PROJECT TITLE  
**Domremy College Solais Project**

### STORMWATER MANAGMENT CONCEPT PLAN – CIVIL ENGINEERING

## **RE: DA2018/0076 DOMREMY COLLEGE: RESPONSE TO REQUEST FOR ADDITIONAL INFORMATION**

**RE: DOMREMY CATHOLIC COLLEGE - 121 FIRST AVENUE, FIVEDOCK (DA 2018/0076)  
LETTER OF RESPONSE TO COUNCIL**

<div>Scale</div> <div>1:400 @ A3</div> <div><div>0m</div><div>4</div><div>8</div><div>12</div><div>16</div></div>

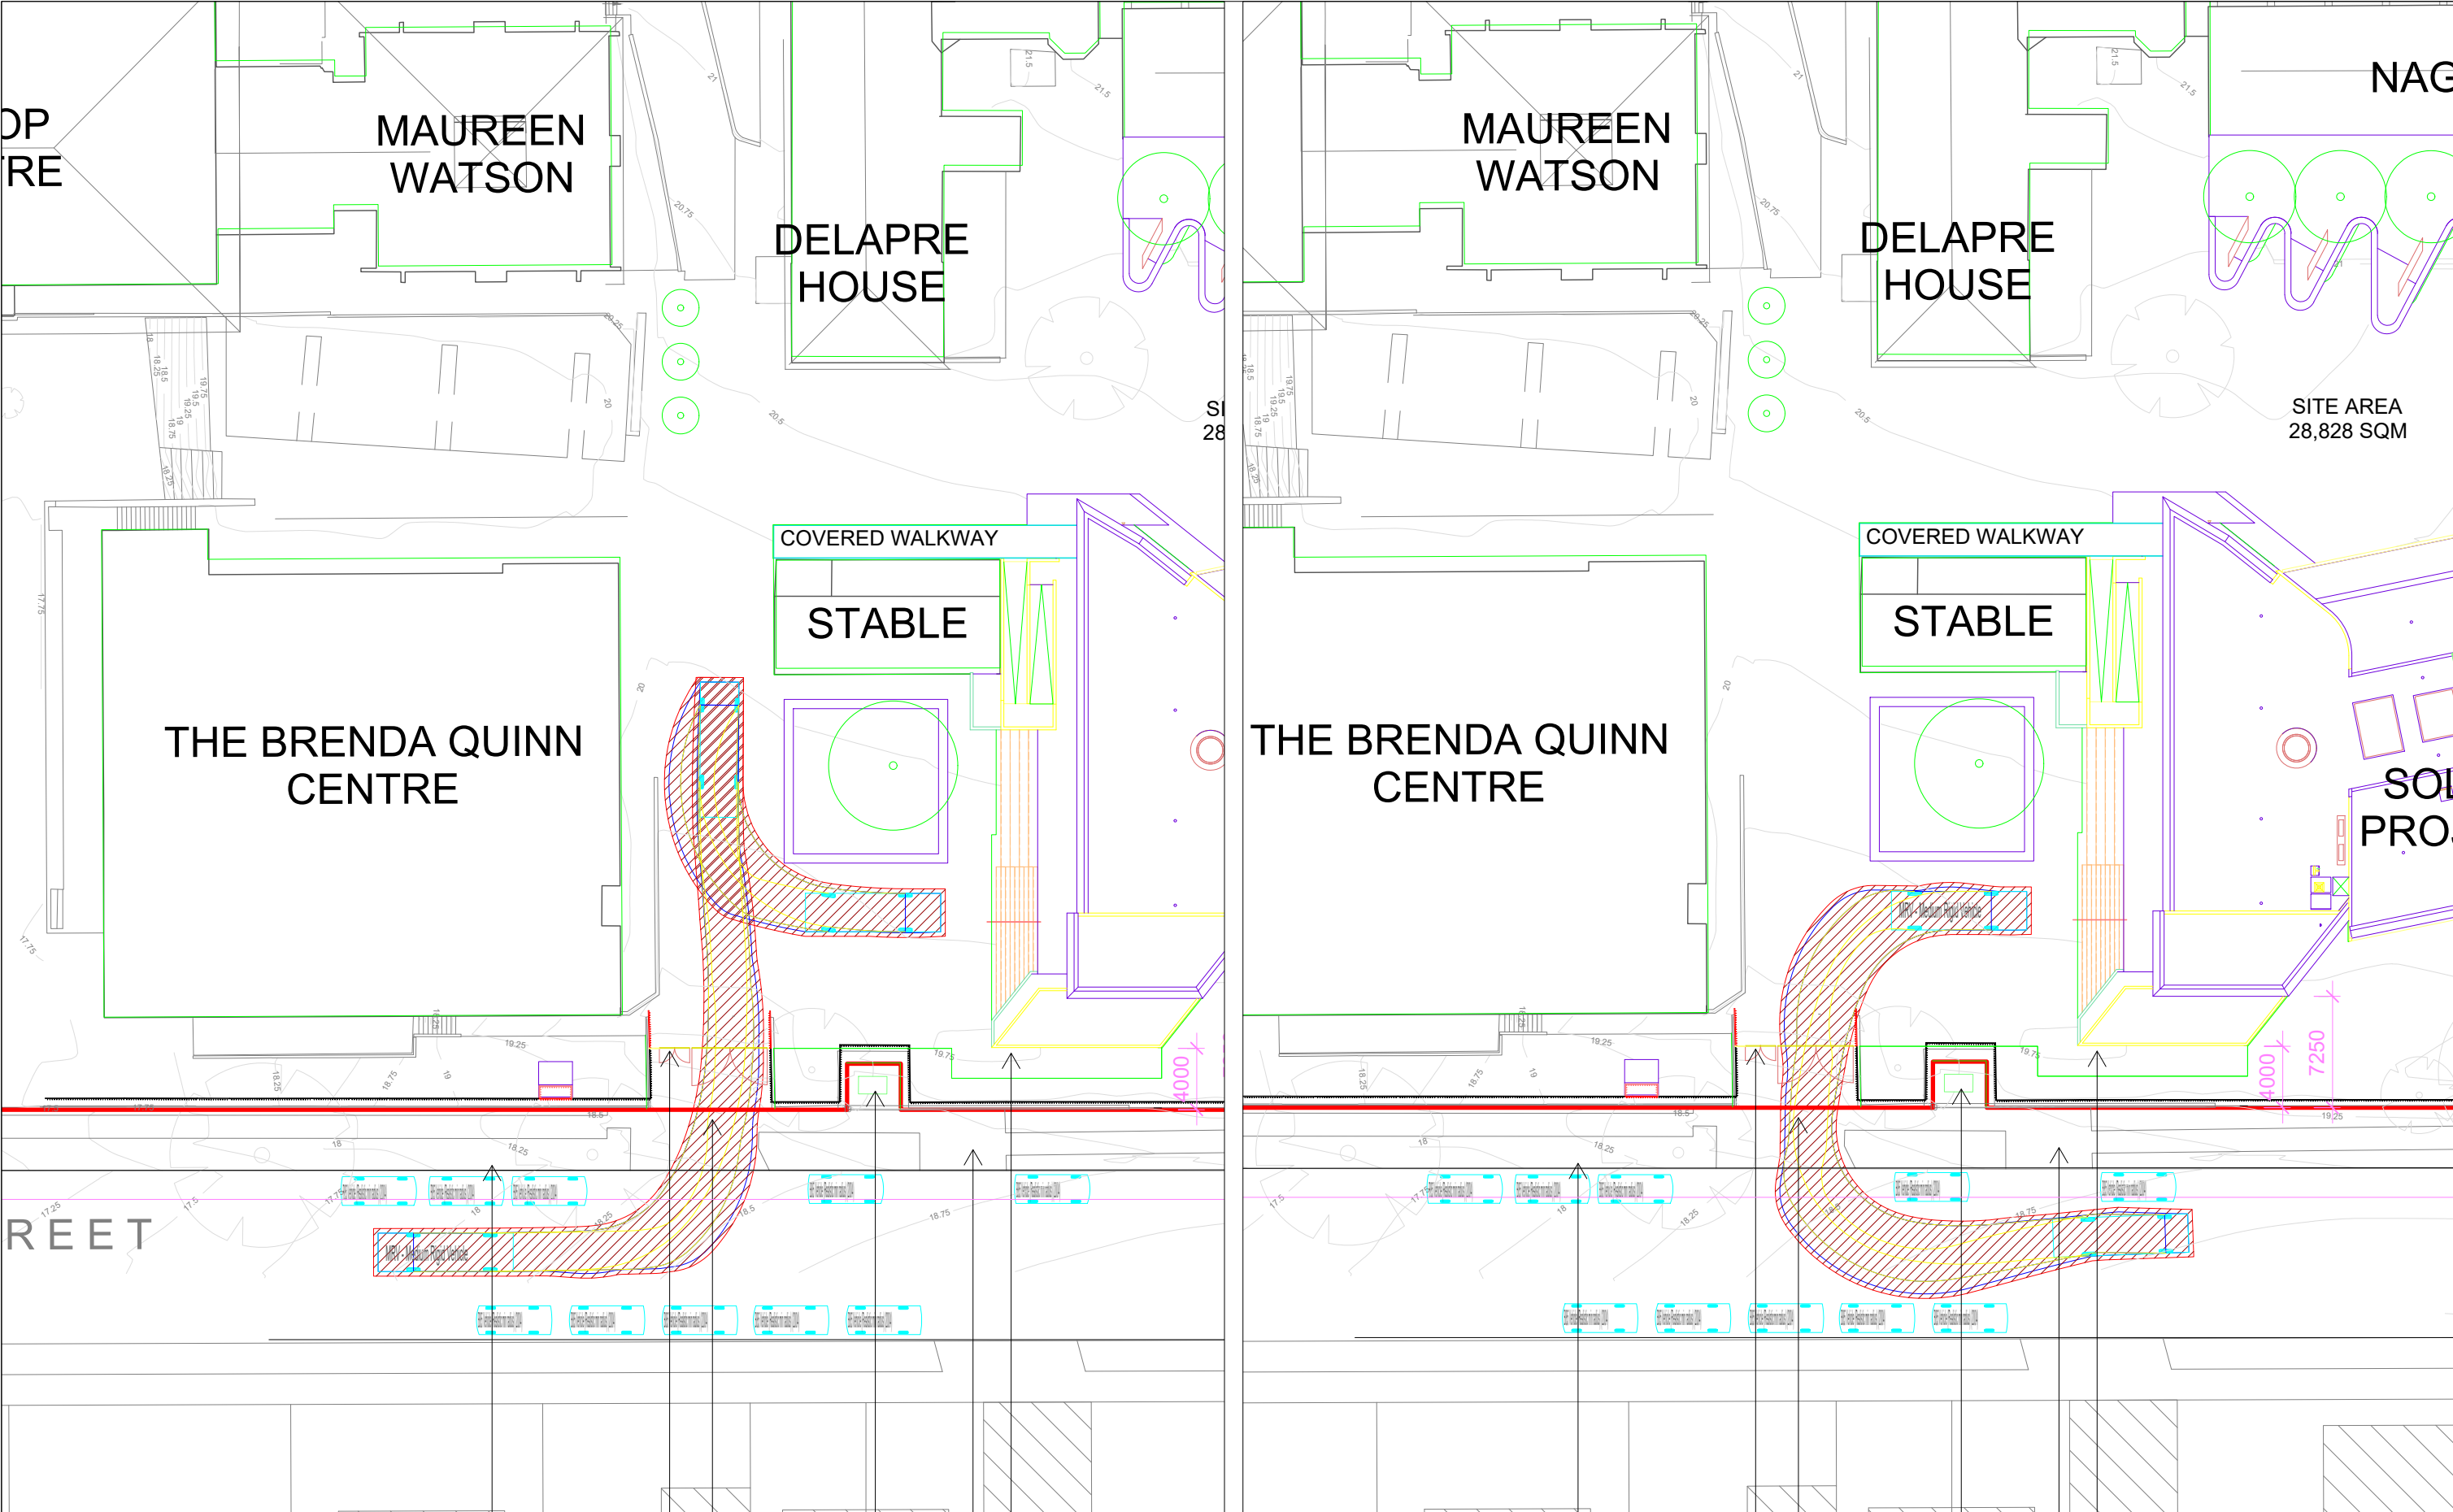
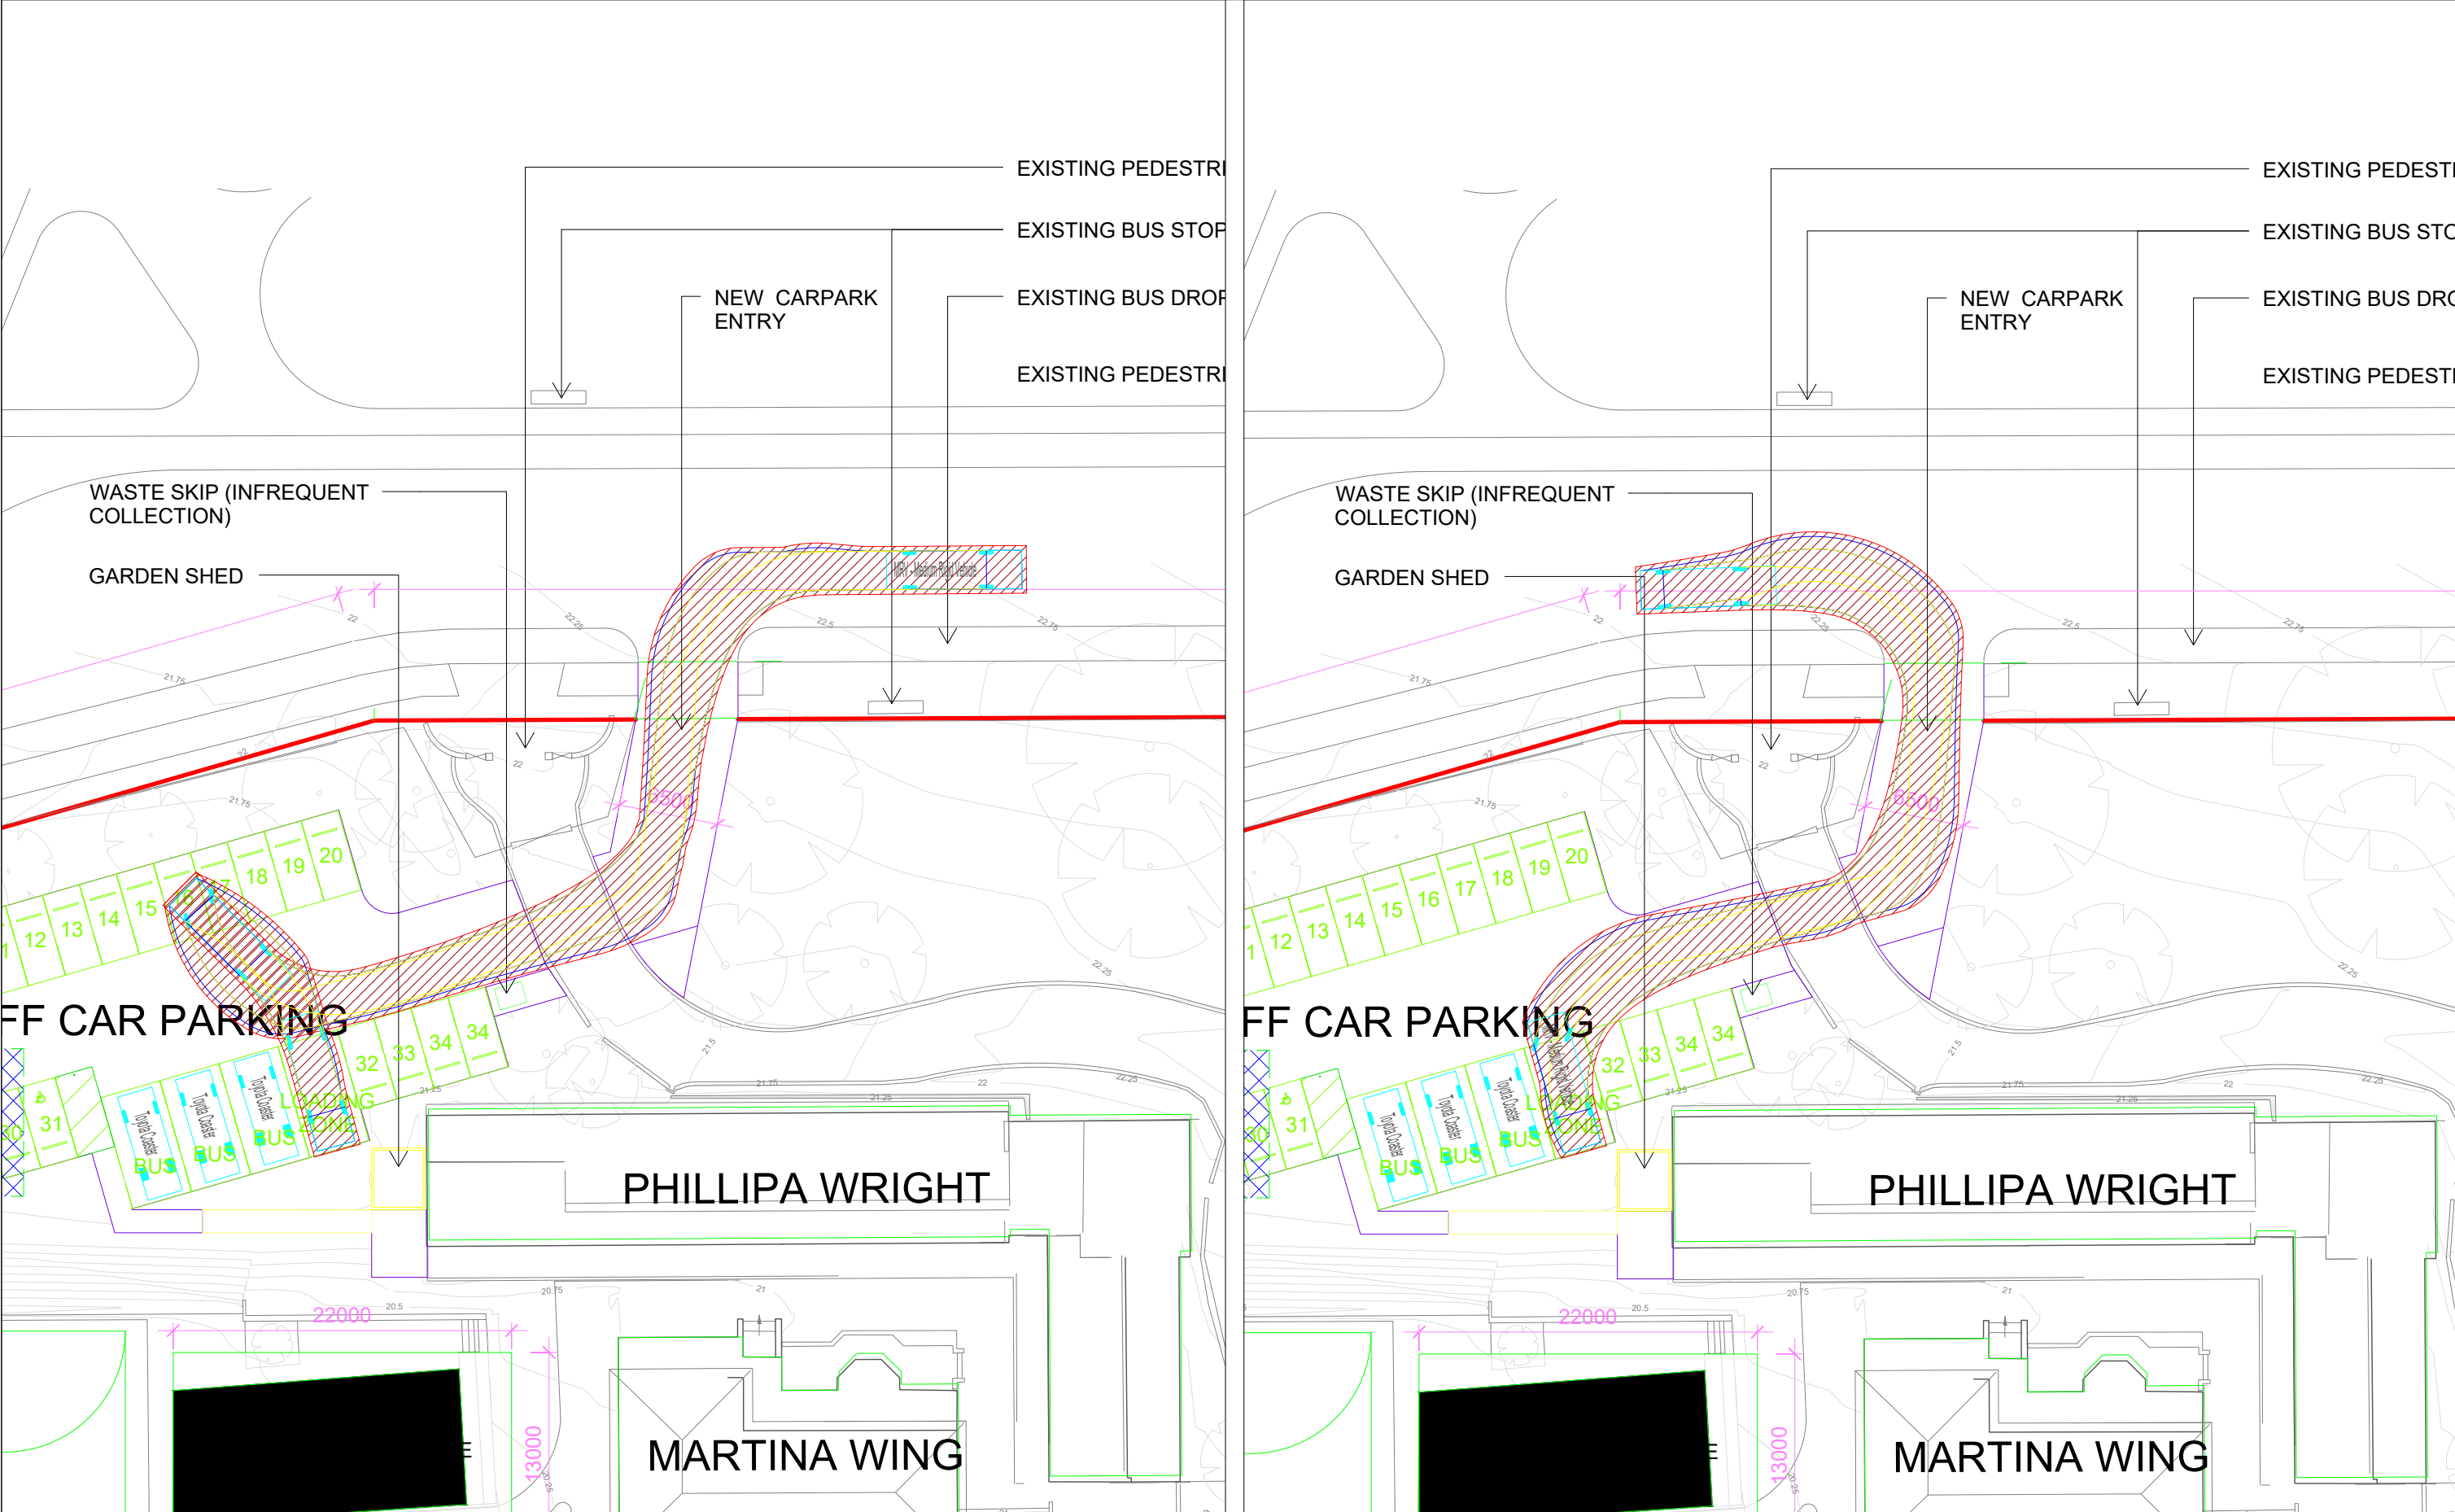
The revised arrangements have also been assessed using swept path analysis for a 7.6 metre Toyota Coaster and 8.8 metre Medium Rigid Vehicle (MRV). The results are included in **Attachment 2** and confirm that satisfactory entry and exit movements will be achieved, clear of Tree 38. We do however note that access by an 8.8 metre MRV will only be permitted outside of school hours when the car park is vacant. This will ensure that there is ample space for an 8.8 metre MRV to turn around on-site as demonstrated by the swept path results.

## Attachment 3

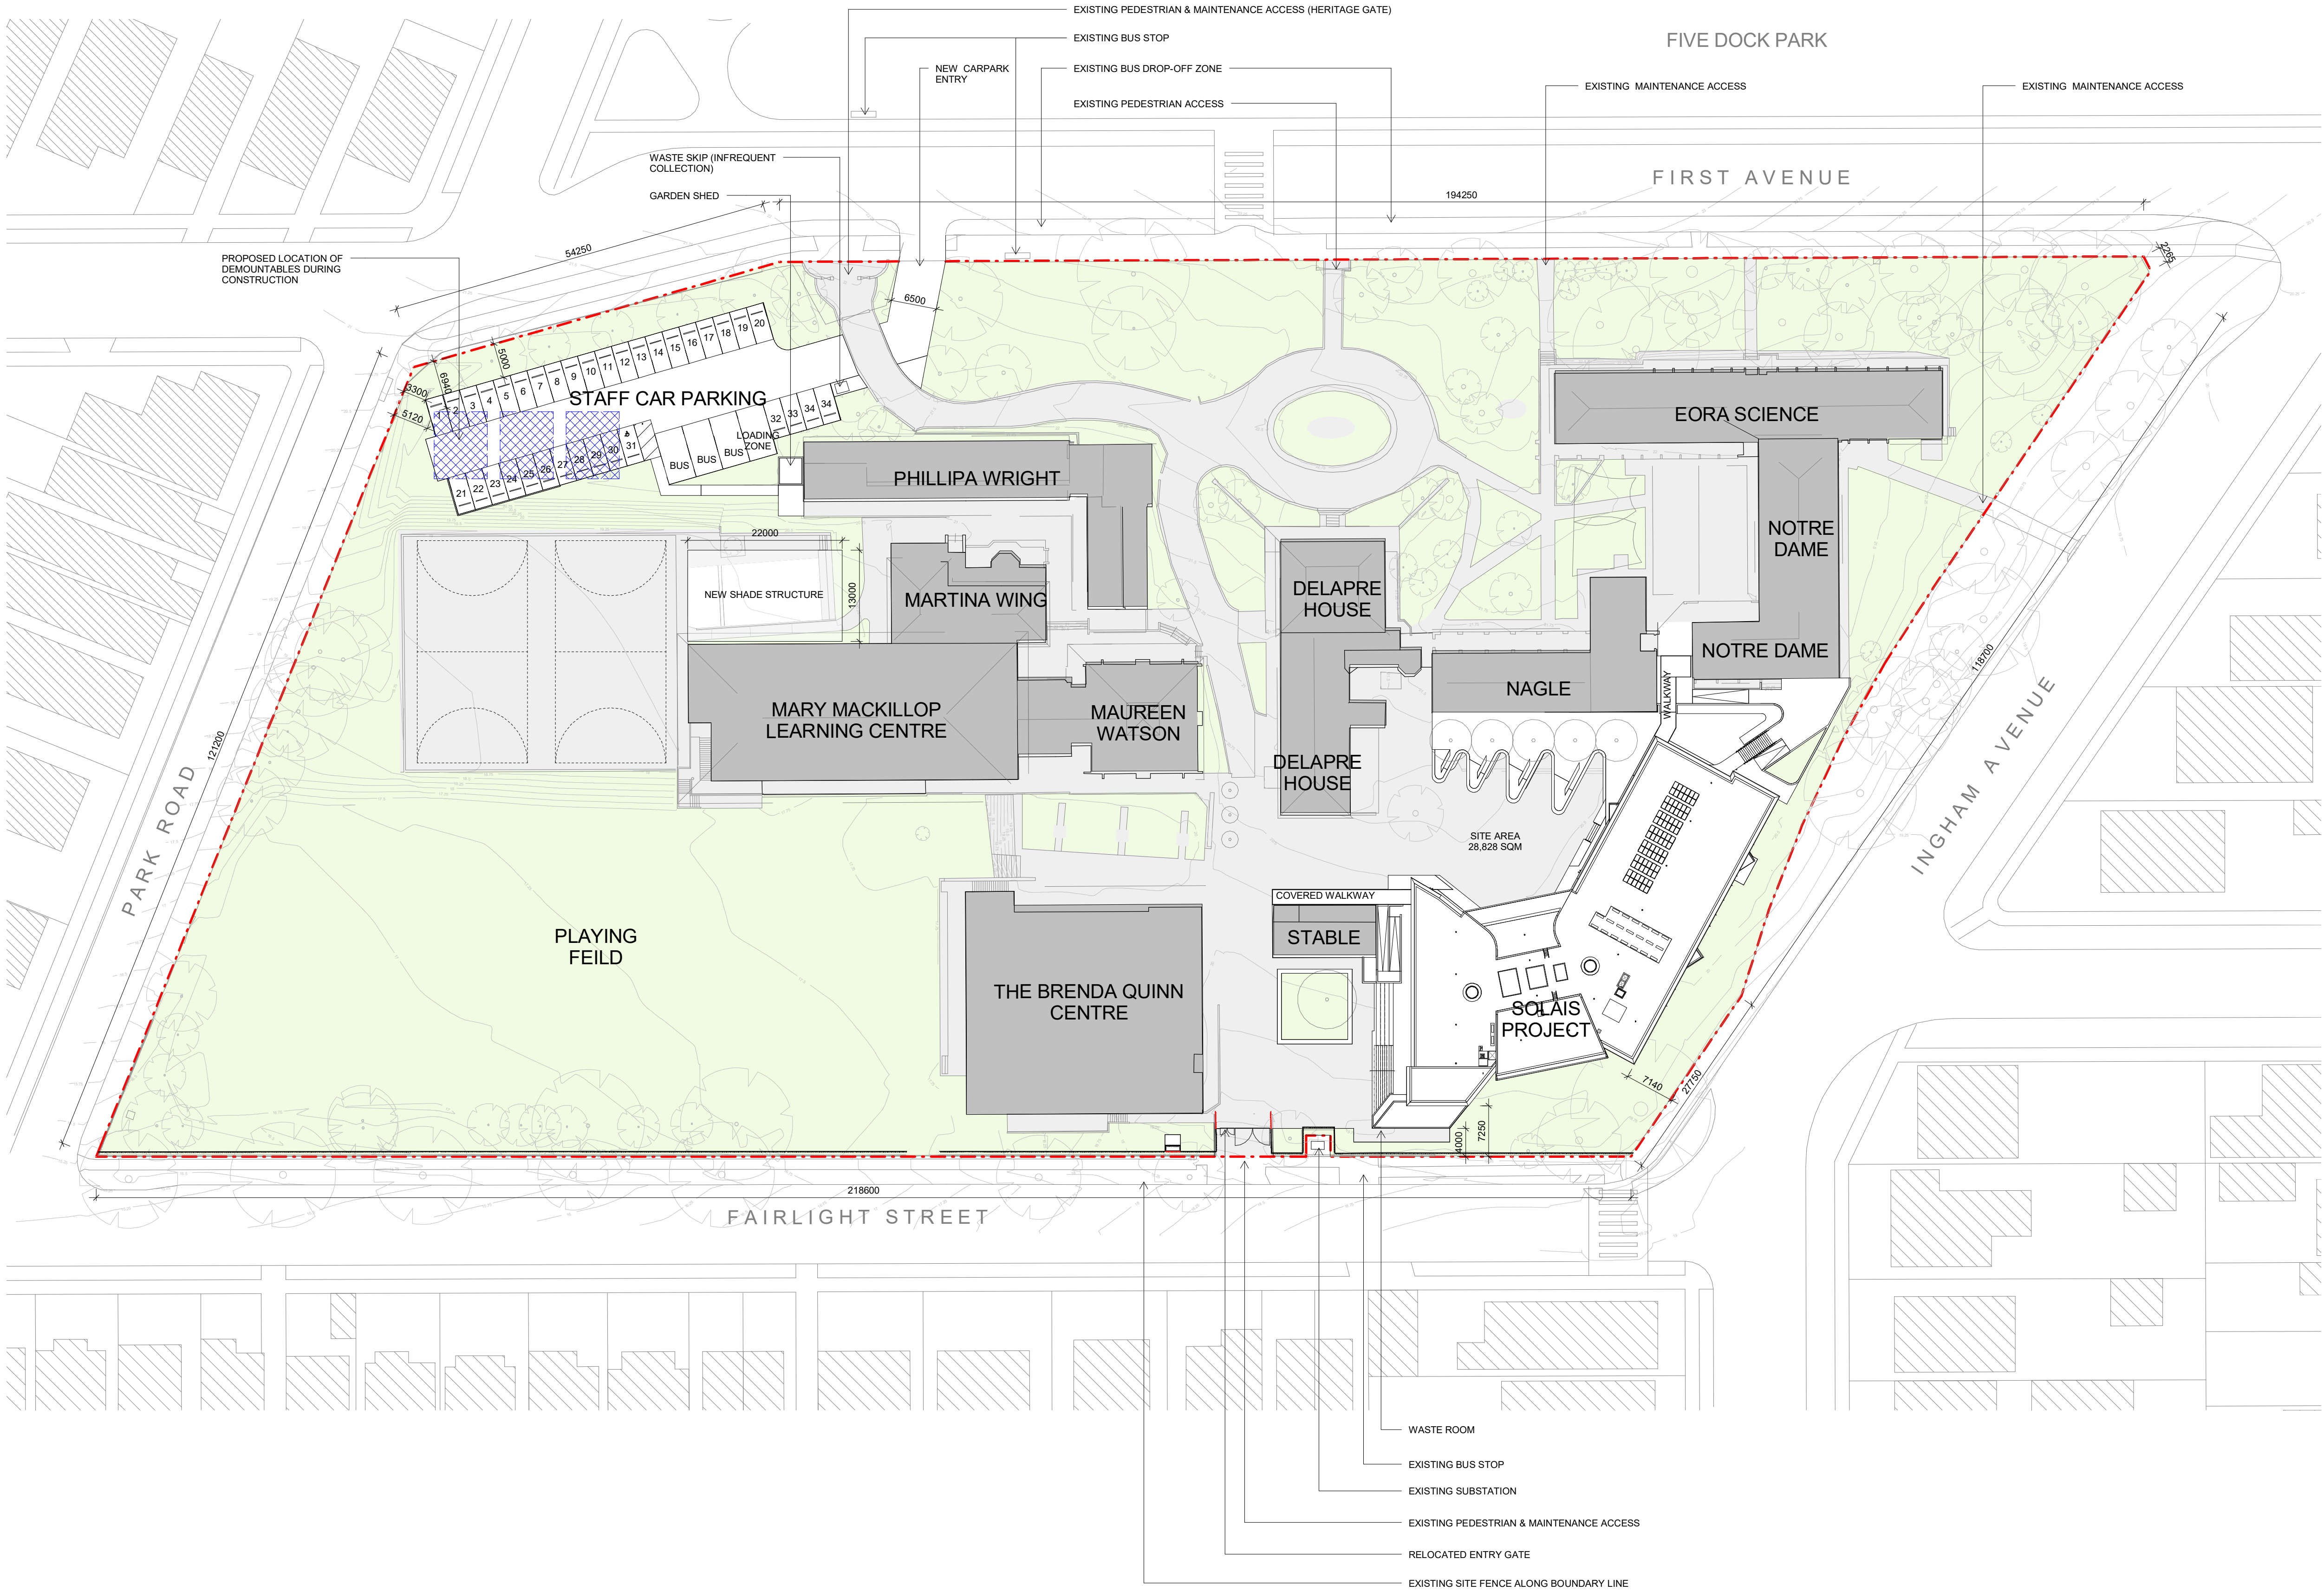
Separate to the above, we note that comments have been received from Council's tree officer and heritage advisor advising that the proposed driveway onto First Avenue should be relocated to ensure that Tree 38 is able to be retained. In response, we note that the alignment of the First Avenue driveway and internal roadway have been reconfigured to ensure that these are clear of Tree 38 and importantly, that Tree 38 is able to be retained. The revised arrangements are shown by the amended Site Plan, prepared by Hayball, included in **Attachment 3**.
